CITY OF ALBUQUERQUE

RE: **Lot 17 Block 6 Unit 22 SAD 228**
6224 Camino Alto NW
Grading and Drainage Plan
Engineers Stamp Date 12/16/2023 (D10D003B17)

Based upon the information provided in your submittal received 12/20/2023, this plan is approved for Grading Permit.

ENGINEER'S SEAL	Lot 17 Blk 6 U 22 VC 6224 CAMINO ALTO CT GRADING AND DRAINAGE PLAN	DRAWN BY DEM
		DATE 12-16-23
12/16/23	 P.O. BOX 53204 ALBUQUERQUE, NM 87199 (505) 321-8099	Lot 17 Blk 6 U 22 VC.DWG
DAVID SOULE P.E. #14522		SHEET # C1
		JOB #

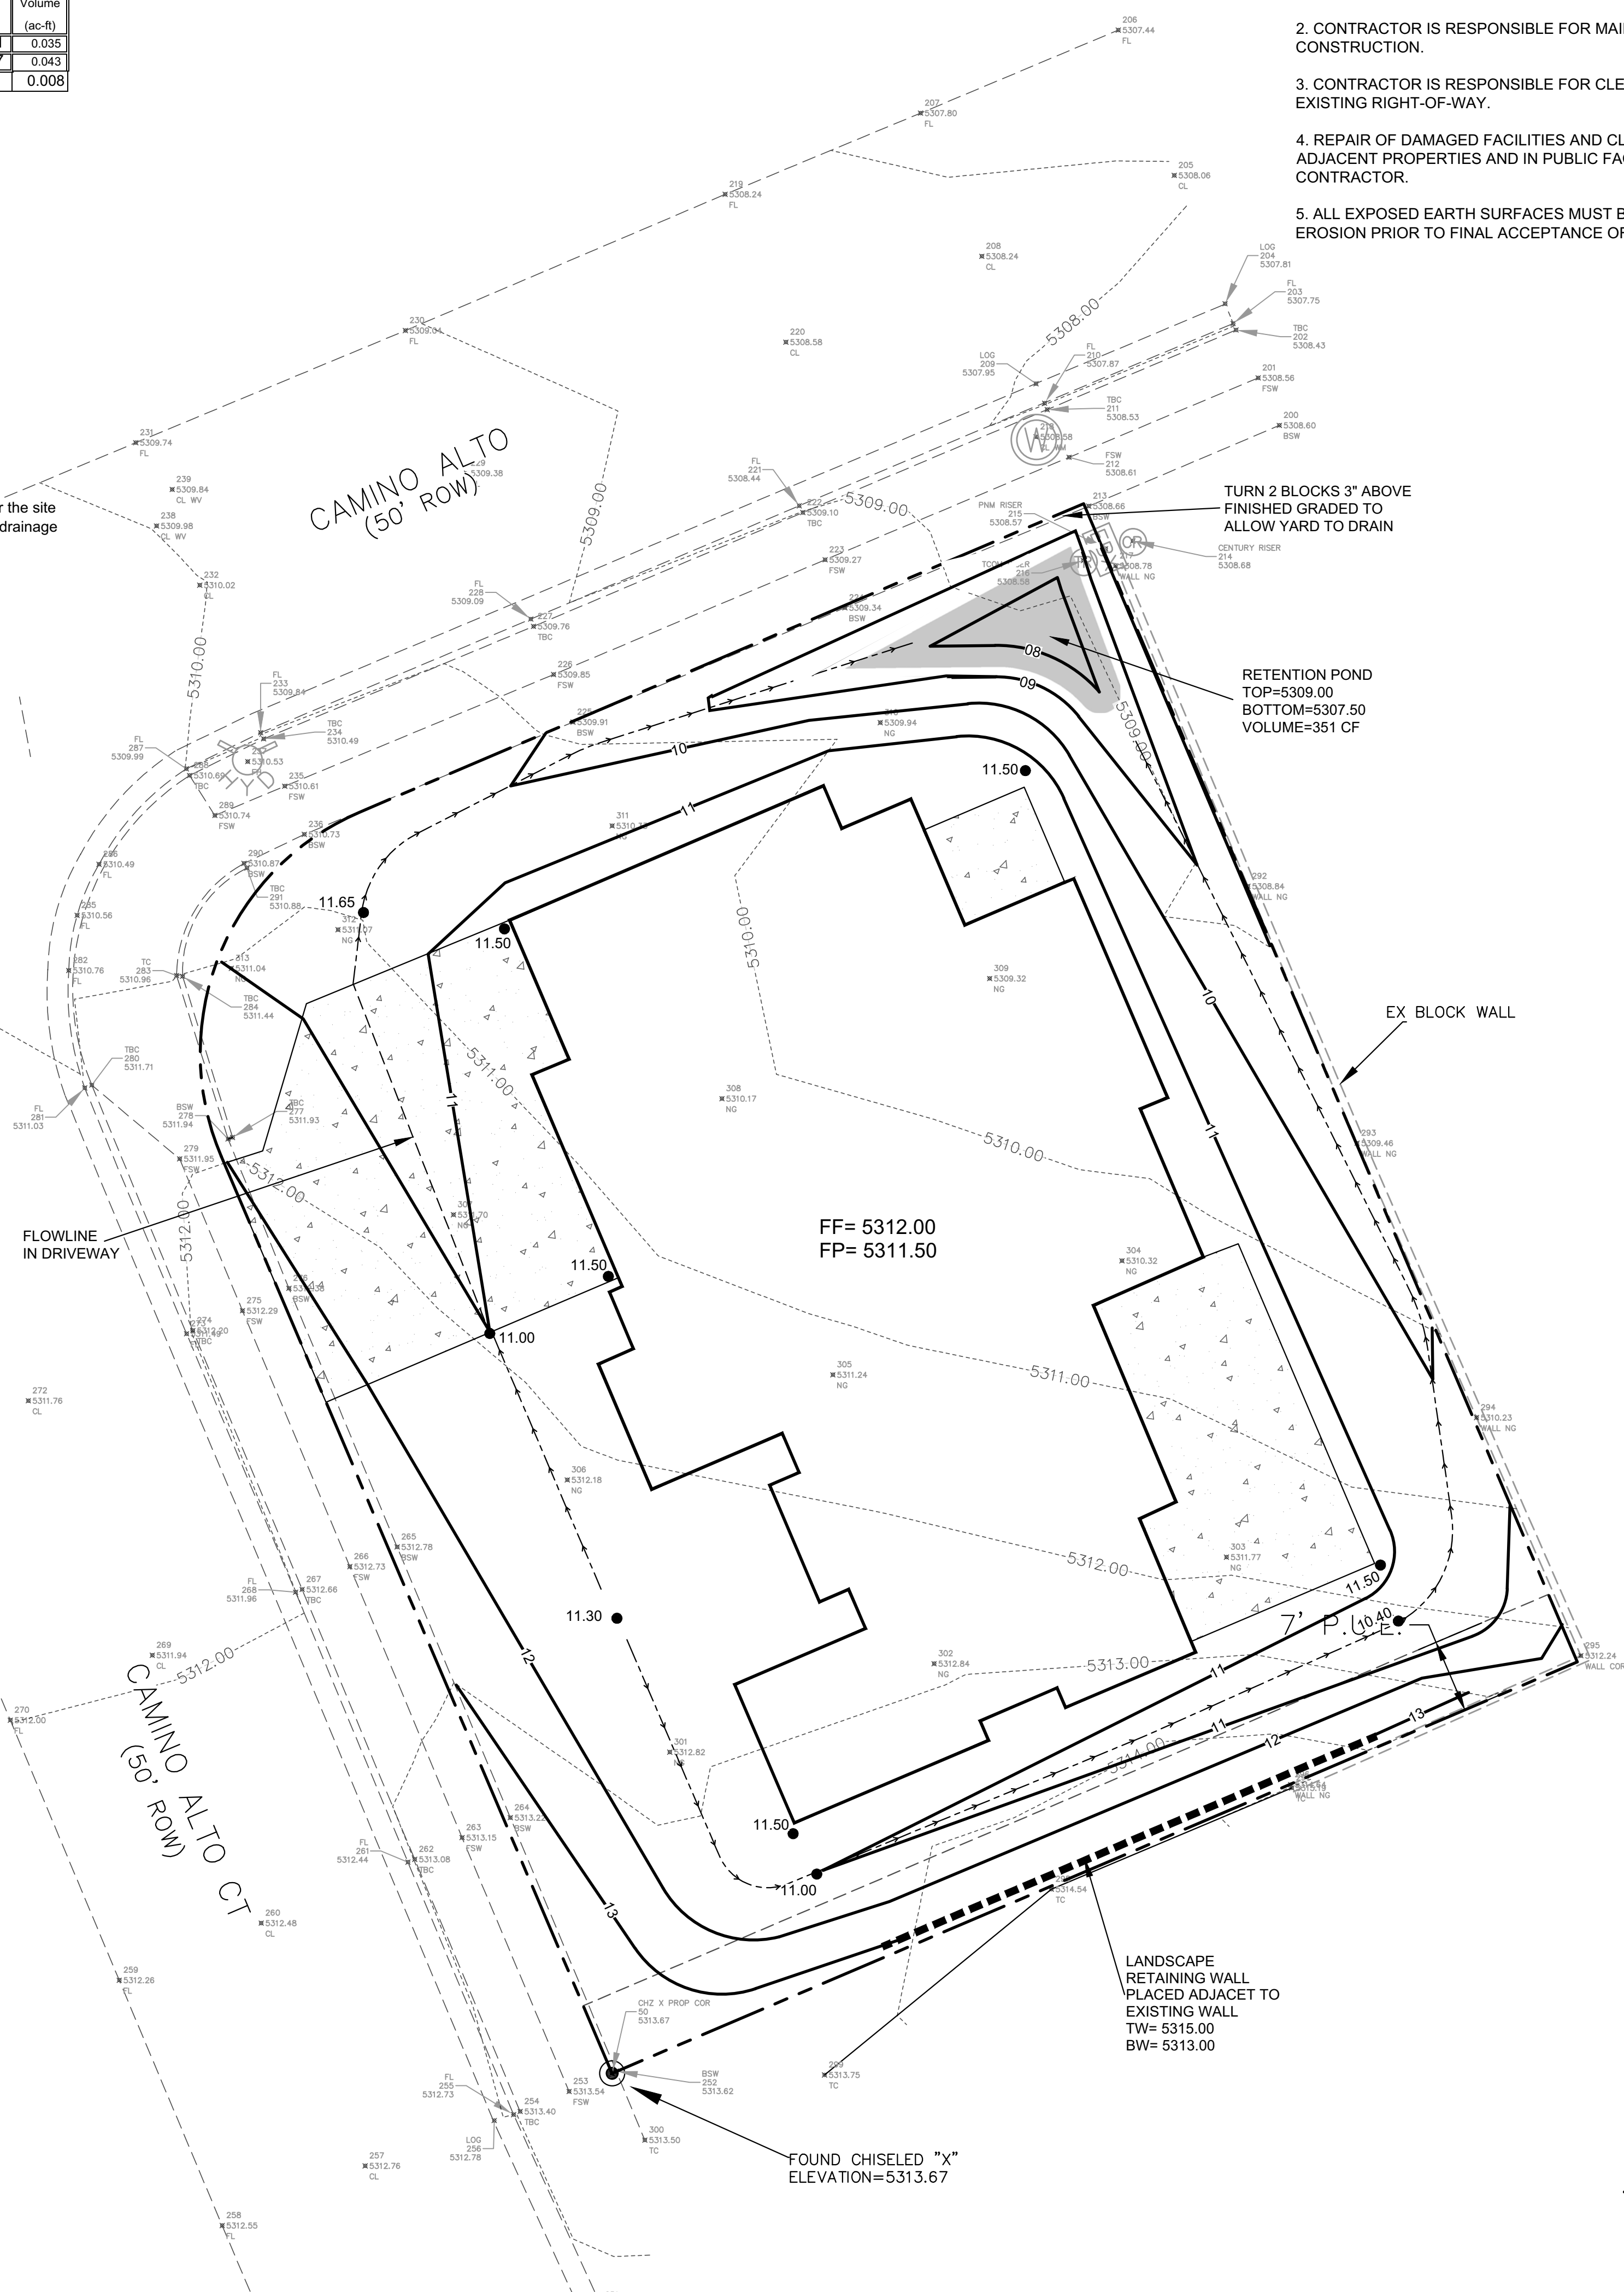
Prior to Building permit approval a Pad Certification will be required, provided by the Engineer or a registered Land Surveyor.

Advise the owner contractor not to use dirt as a ramp to climb the curb, use lumber or crusher fines for this purpose.

Reiterate to the Owner/Contractor that a separate permit for a garden/retaining wall must be obtained with the approved G&D plan and Pad Certification. Also, if a swimming pool is to be placed the grading and drainage plan will change and will need to be resubmitted.

Prior to Certificate of Occupancy release, Engineer Certification per the DPM checklist is required.
